Wharf Street Safety Improvements

MINUTES OF A MEETING OF THE HARBOURSIDE PRECINCT WORKING GROUP HELD IN THE MAYORS LOUNGE, SECOND FLOOR, CIVIC CENTRE ON THURSDAY 27 MARCH 2014 COMMENCING AT 3.30 PM

DCC - SOUTH DUNEDIN CYCLE NETWORK SCHEME DESIGN PLANS **ROUTE 10 - HARBOURSIDE**

SUBJECT: ROBERTS STREET/ WHARF STREET INTERSECTION

FIGURE 1: Proposed safety improvements at Roberts Street

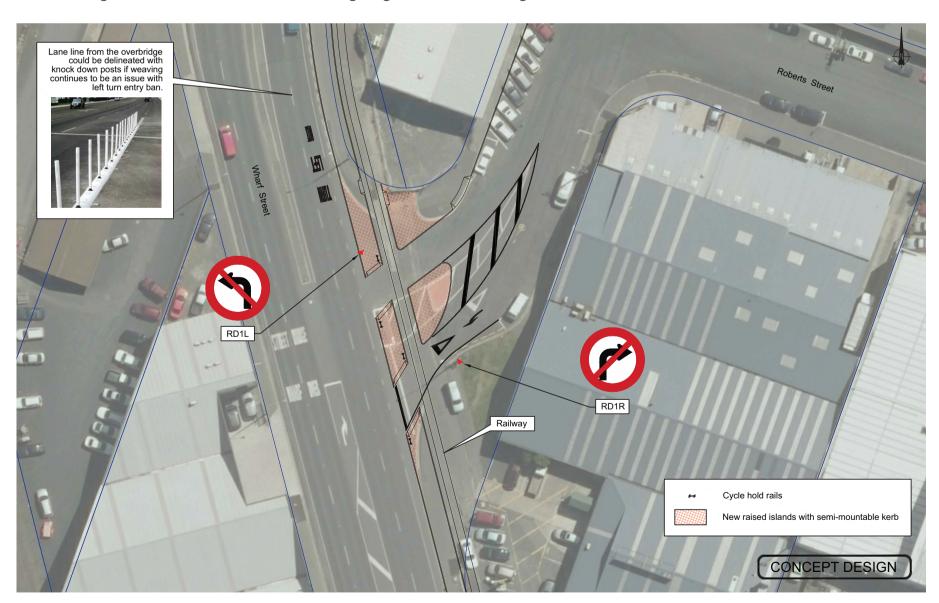
The main safety issue here is that vehicles travelling south on Wharf Street conflict with traffic from the Jetty Street overbridge turning left into Roberts Street. Turning right out of Roberts Street also creates safety concerns.

Our proposal is to allow vehicles coming out of Roberts Street to turn left only. Vehicles coming down off the Jetty Street overbridge and south along Wharf Street will not be able to turn into Roberts Street. Vehicles heading north will still be able to turn right into Roberts Street.

To prevent drivers merging immediately after the overbridge, the two southbound Wharf Street lanes will be delineated between the overbridge and Roberts Street.

FIGURE 2: Proposed safety improvements at Kitchener Street

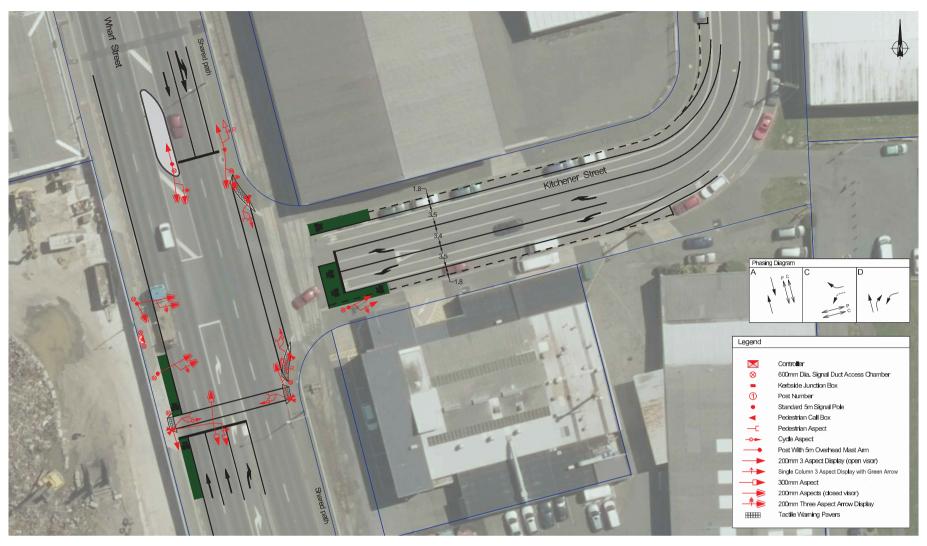
We recommend installing traffic lights at the intersection of Kitchener and Wharf Street so traffic can get into and out of the harbour area safely and efficiently.

The lights will be coordinated with the nearby intersection of Wharf and Strathallan Streets.

FIGURE 3: Proposed safety improvements at Birch Street

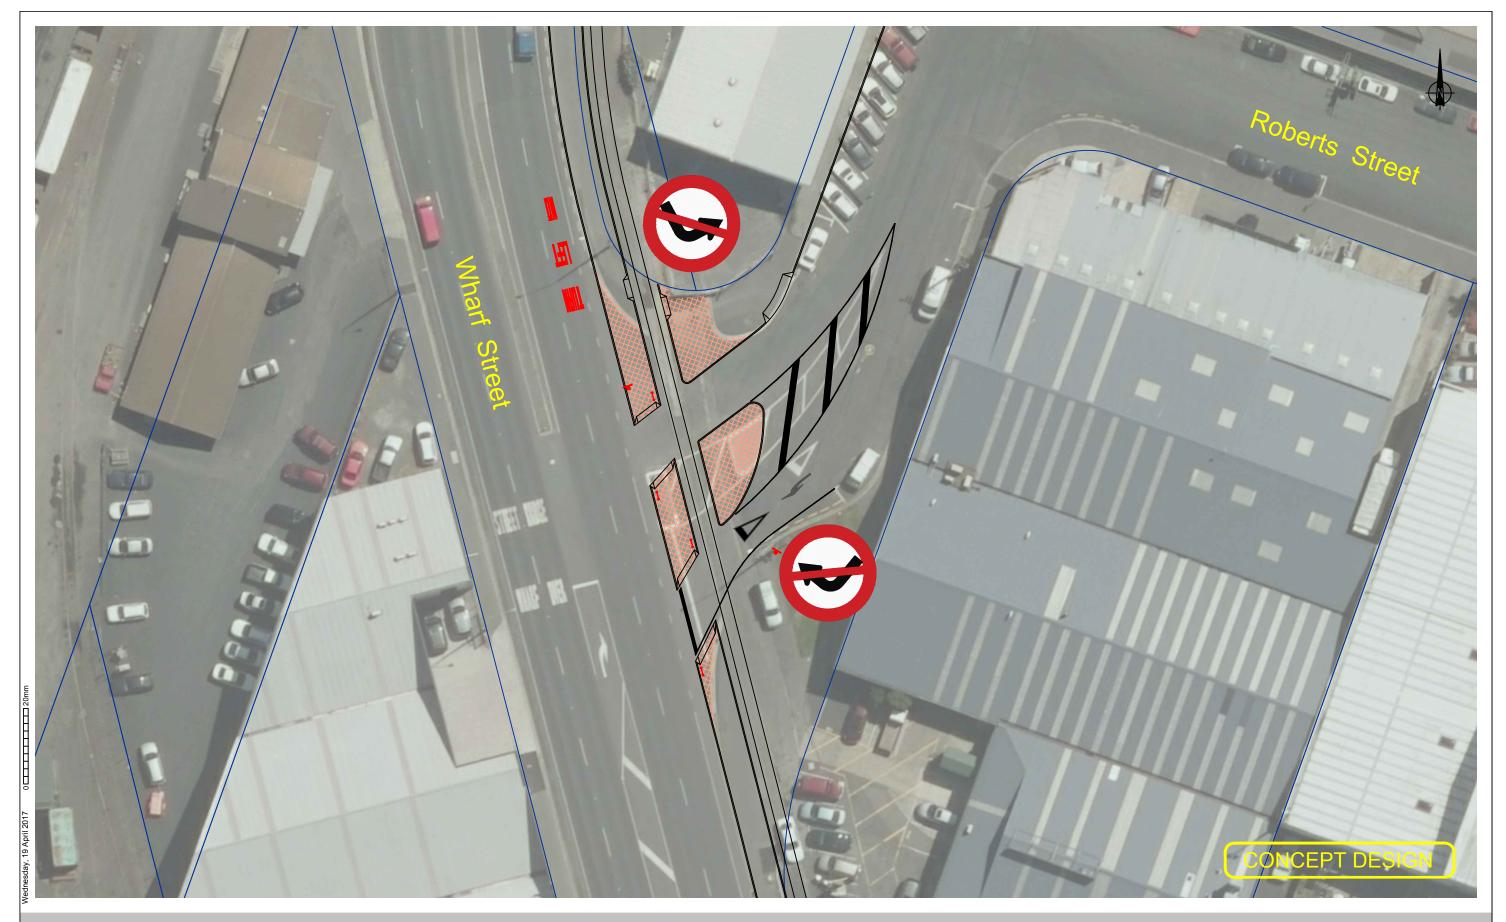
The layout of the median space at the Wharf and Birch Street intersection gives vehicles little space to queue. There is no right-turn lane (into Birch Street) on Wharf Street, and the overbridge obstructs visibility.

We propose stopping traffic from turning right from Wharf Street into Birch Street and improving the right turn out of Birch Street within the limited median space.

SK1100 approved (PD)

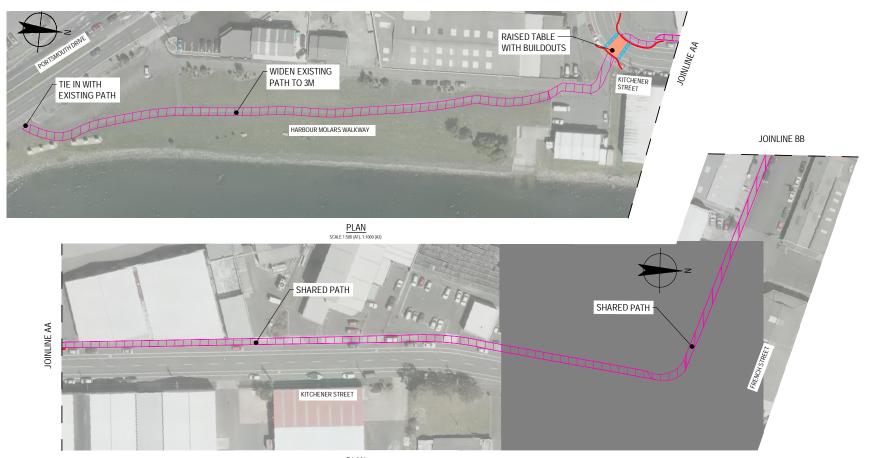
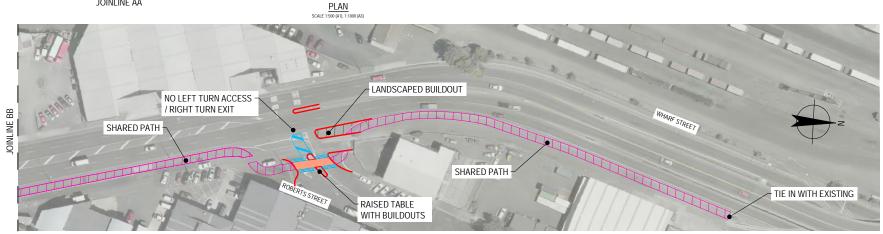
Andrew Fergus presented his memorandum on the two options, Routes 1 (black) and Route 3 (green), along with concept plans for each option. Both options restrict movements at the Roberts/Wharf intersection, banning right turns out of Roberts Street and left turns into Roberts Street.

Hudson Biggs brought up concerns over the sight distances at the existing cycle crossing in Wharf Street.

Dave Watson voiced concerns over Option 1 as the crossing point impacts on Dive Otago's driveway (at corner).

Dave Watson requested we install a physical barrier on the off ramp so vehicles are unable to cut across left lane and access Roberts Street.

<u>Action:</u> Andrew Fergus to check stopping distance requirement for sight distance at existing cycle crossing point.

<u>Action:</u> Andrew Fergus to look at possible options to maintain Dive Otago access to driveway.

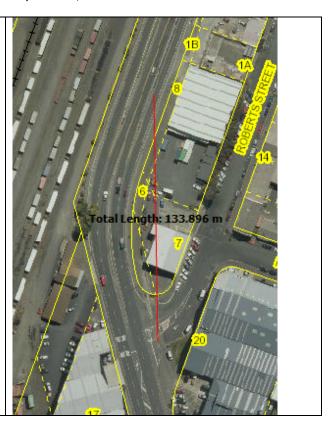
4. The minimum gap sight distance (MGSD) for the driver of an entering vehicle to see a vehicle in a conflicting traffic stream in order to safely commence the desired movement is approximately 133 metres. This is based on a right turning vehicle selection an 8 second gap between vehicles to turn right into a 4 lane road where the 85th percentile approach speed of southbound vehicles is approximately 60 km/h.

<u>Comments</u> The diagram on the right shows MGSD cannot be achieved.

During peak hourly flows it is very difficult to find a gap between vehicles in excess of 8 seconds in which motorist's (excluding the restricted sight distance) can safely undertake a right turn.

SK1100 approved (PD)

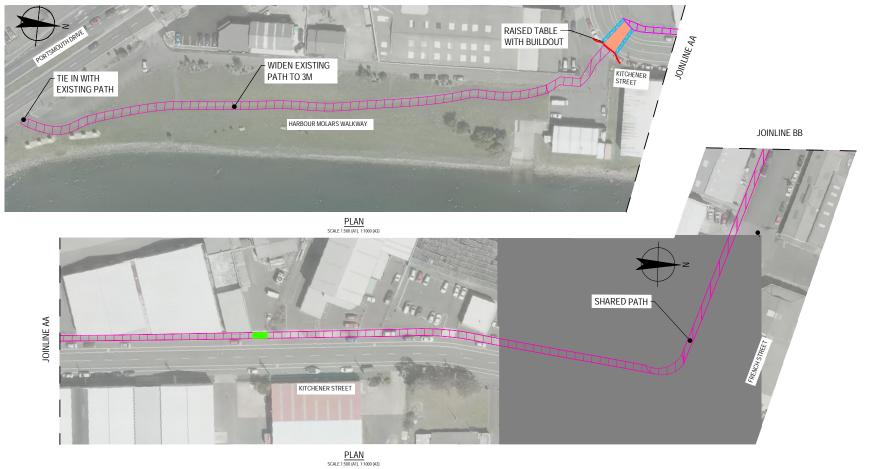
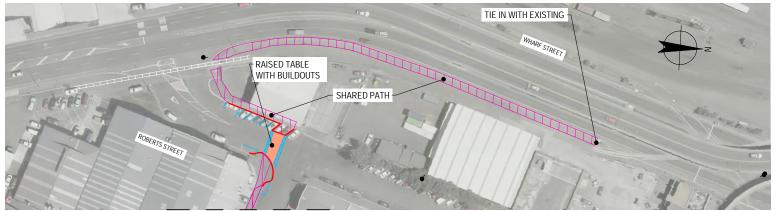
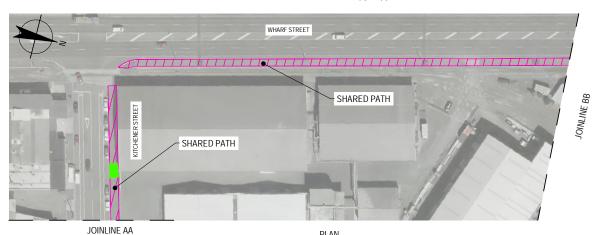
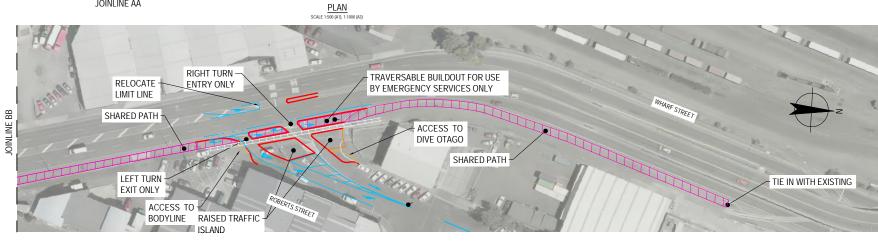
Changes have involved the alteration of the Roberts Street/ Wharf Street Intersection, with the left out and right in movements being moved further apart to provide for additional space for cyclists in the centre of the intersection.

The access to Bodyline is now from Roberts Street, with access no longer available from Roberts Street. This aligns with the discussions held with KiwiRail in allowing access to their business by not entering over the rail tracks.

The design assumes that eastern rail track can be removed, and this has been verbally agreed with KiwiRail.
